**CITY OF DANA POINT
PLANNING COMMISSION
AGENDA REPORT**

SUBJECT: PRELIMINARY REVIEW (PA16-0083) BY THE PLANNING COMMISSION OF A PROPOSED 2,365 SQUARE FOOT DETACHED SECOND DWELLING UNIT INCLUDING AN ATTACHED GARAGE, AND A NEW 2,050 SQUARE FOOT ACCESSORY STRUCTURE LOCATED AT 32726 RACHEL CIRCLE, WITHIN THE RSF 7 ZONING DESIGNATION WITH THE PR-5 OVERLAY

Subject: **Preliminary Plans for a Second Residential Unit and Accessory Structure at 32726 Rachel Circle**

Glickman Res. - 2nd Dwelling/Acc. Structure

SITE PLAN

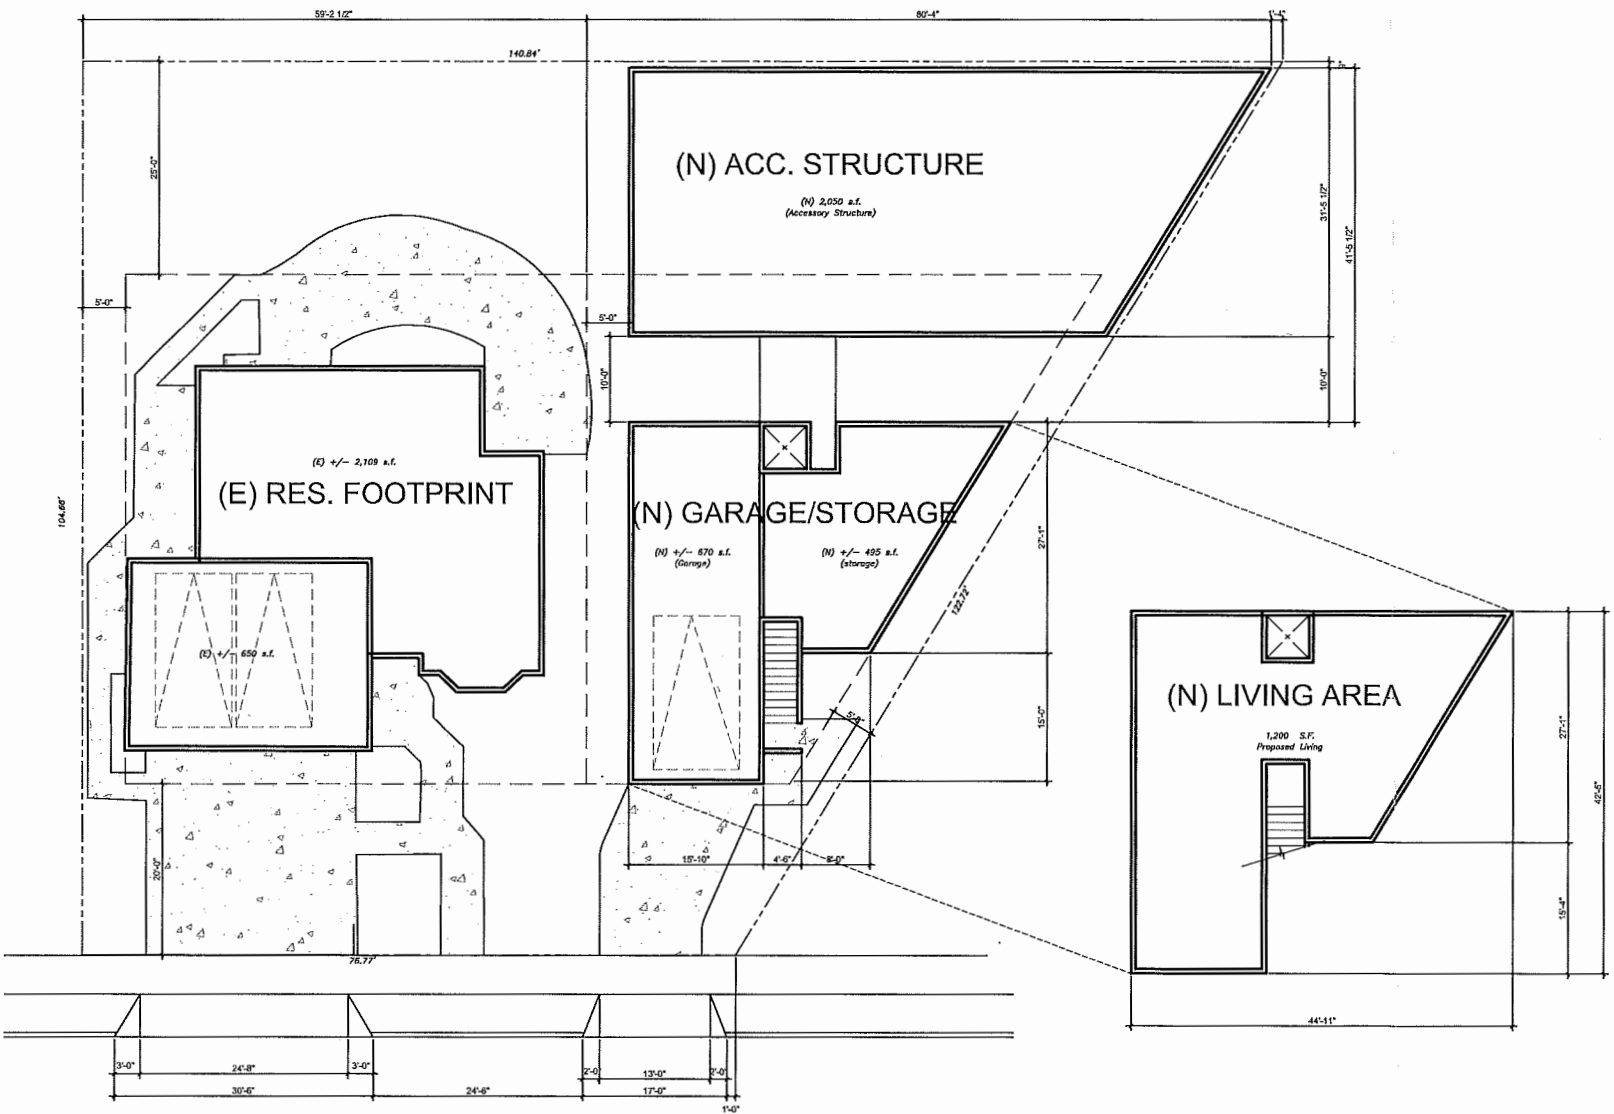
Staff identified and outlined two primary issues related to the scale and proportion of the proposed development in the July 12th letter (Attachment 1) to the applicant. Overall, staff believes the two detached structures totaling 4,415 square feet is not compatible, and will not complement, or enhance the subject and surrounding properties. Discussion relative to the applicable Second Dwelling Unit and Accessory Use zoning standards follow below.

requirements, thus the additional 670 square foot garage is not required. The 1,200 square foot limitation has historically included the storage space within the unit, or within the required parking area. The applicant is proposing 965 square feet of storage space between the proposed oversized garage and identified storage space. The garage and storage area associated with the second dwelling unit is 80% over the maximum 1,200 square foot limitation.

The proposed accessory use/structure is 2,050 square feet and abuts the rear and side yard setbacks. The accessory structure exceeds the size of other accessory structures that are typically found in the RSF 7 Zone and is not "very small in proportion to the principle use", a 2,100 square foot single family residence.

Staff completed a brief aerial photo analysis of the potential projects compatibility with the surrounding neighborhood. As noted above, the neighborhood is generally one and two-story single family residences on large lots. Based on staff's evaluation of the neighborhood, the proposed detached structures would be the only such structures in terms of scale and proportion in the neighborhood, as the typical detached structures are limited to patio covers or small gazebos, nothing on the scale of proposed development on the subject lot.

- Section 9.07.210 (b,1) states that the second dwelling unit shall not exceed 1,200 square feet when detached from the primary dwelling unit. As designed, with 1,200 square feet of living area and 495 square feet of storage area, the unit would exceed the maximum allowed area for the detached unit.

- Section 9.07.210 (b,3) requires that one additional parking stall be provided for the second dwelling unit. As the development standards for primary dwellings only require two covered parking spaces, the one extra parking stall required for the granny flat is already provided for within the three car garage of the primary dwelling. As proposed, the size of the garage you have designed for the granny flat greatly exceeds that which would be required. The standards are established so that second dwelling units may be evaluated under conditions that will assure their compatibility and enhancement to the site and surrounding land uses. Because the number and size of garage spaces proposed (4+) greatly exceeds the one stall that is required, the design would not be compatible with the surrounding neighborhood.

garages, gazebos, workshops, sheds and patios. The accessory building you have proposed far exceeds that which would normally be considered as accessory. A maximum 400-500 square-foot structure would be more in keeping with the size of a typical garage, gazebo, workshop or shed.

- Accessory Use — a use of a portion of land or building which is customarily and clearly incidental and subordinate to the principal use of the land or building which is located on the same lot as such principal use. Accessory uses are typically very small in proportion to the principal use. The proposed accessory structure, which is over 2,000 square feet cannot be considered "very small" in proportion to the principal dwelling (which is indicated on the topographic survey as being only 1,796 square feet in size).

As preliminarily designed, staff would not be able to determine the design is in clear compliance with applicable standards of development. I recommend, in order to "assure their compatibility and enhancement to the site and surrounding land uses", that you reduce the size of the accessory structure in the rear yard to less than 500 square feet and that you reduce the Second Dwelling Unit to no more than 1,200 square feet and that you rely on the third parking space that is already provided in the primary dwelling. If the changes outlined above were in fact made, it is more likely that staff could make a determination that the site design is in compliance with the City's General Plan and Zoning Code, without requiring a public hearing for a Site Development Permit (see Chapter 9.71.020 Site Development Permit Required). Please be advised, however, that staff cannot commit to any particular determination at this point in time without the ability to review and analyze a revised set of plans.

Matt's objection was the proposed 2nd dwelling exceeds the 1200 sq ft maximum allowable by code. His position was the 495 sq ft storage unit located on ground level should be added to the 1200 sq ft living area on the 2nd level, which would exceed the max. 1200 sq ft.

I was advised by planning previously that storage area is allowable and encouraged by the code requirements. The storage area is non livable space, with no Plumbing or HVAC. I see no reason why covered storage area would be added to the livable square footage. The only code information found on this issue by Planning Dept supports my position:

The 495 sq ft of lower level non livable storage space, meets clause (6) requirement above, "shall have adequate storage."

In addition, as can be seen on the Plot Plan, the storage area is NOT accessible to the 2nd Dwelling living area. To access the storage area, you would have to exit the living area, go down a flight of stairs and open a door which is only accessible from outside.

My Plot Plan includes the “REQUIRED” one additional covered parking stall for the 2nd dwelling (Granny Flat). This clearly seems in compliance with the garage requirements for a 2nd dwelling as the code states above.

Matt’s next objection is, the 4 stalls would not be compatible with the surrounding area. I am perplexed by this. As stated, the existing Primary Dwelling has a 3-car garage, which is the SAME as every other house on the street. So this is clearly compatible with the surrounding area. The code “requires” 2nd dwelling units to include an additional parking stall, which is provided in my Plot Plan.

A workshop is listed as a structure type for Accessory Building. I will try to address the “incidental” as it relates to the size of the workshop for this project. Since there are no codes or specific requirements, I will use numbers to provide a “sense of scale” of the workshop by using two sensible benchmarks, Workshop size vs. lot size, and Workshop size vs. total sq ft of enclosed space.

For clarification, the principle dwelling is NOT 1796 sq ft as stated in Matt’s letter. It is 2109 sq ft as shown on the Plot Plan. The 1796 sq ft represented the foot-print sq ft. of the Primary structure, which is ONLY applied for use in the landscape calculations, also shown on the Plot Plan. In addition, I feel Matt’s comparison of the workshop’s relative size is a very unfair statement and offers no justification for his position. I suggest the two benchmarks I offered above are a fair analysis of the relative size of the workshop.
